# Birks Grange Village Blocks A-E 22/1746/RES

2nd February 2023

Exeter Cycling Campaign is grateful for the opportunity to comment on the application for approval of reserved matters for alterations and refurbishment of Birks Grange Village. [22/1746/RES](#)

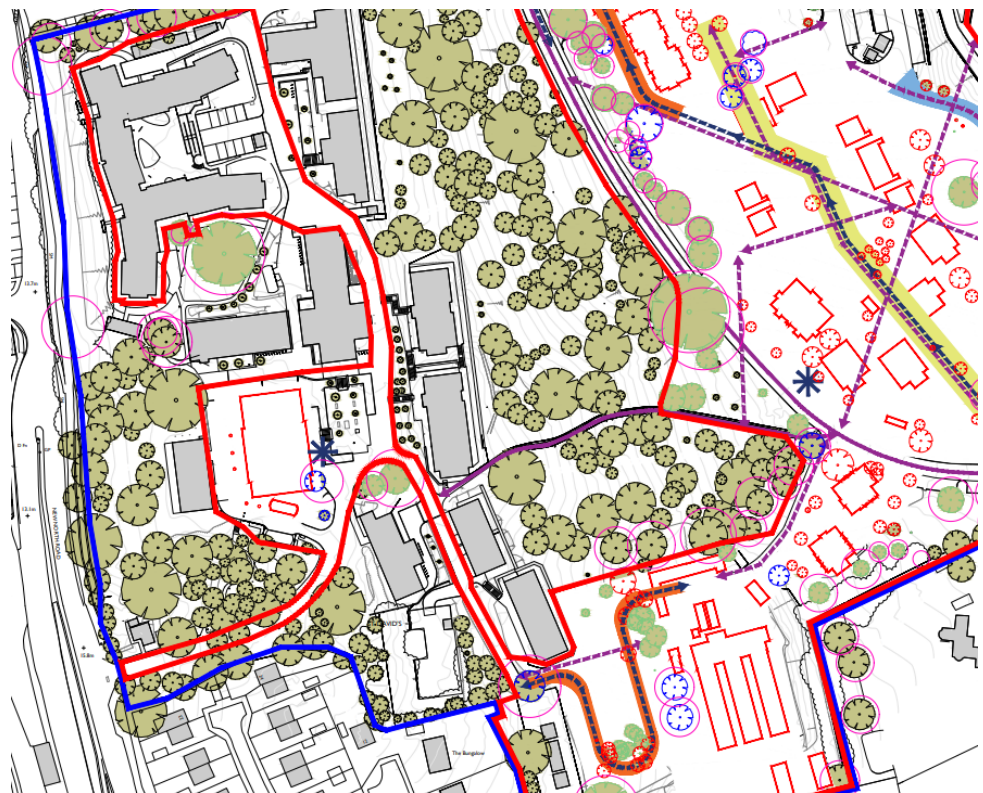
The access drawing shows the access arrangements for people driving and walking. However, there appears no provision for people cycling. Granted, the topography of the site is challenging.

However, the 'estates only' road west of the greenhouses could be opened up as a cycle path which flattens the gradient up to Clydesdale Avenue.

This road is described as being available for private cars during visitor weekends. It seems a small provision to open this up throughout the year for people cycling.
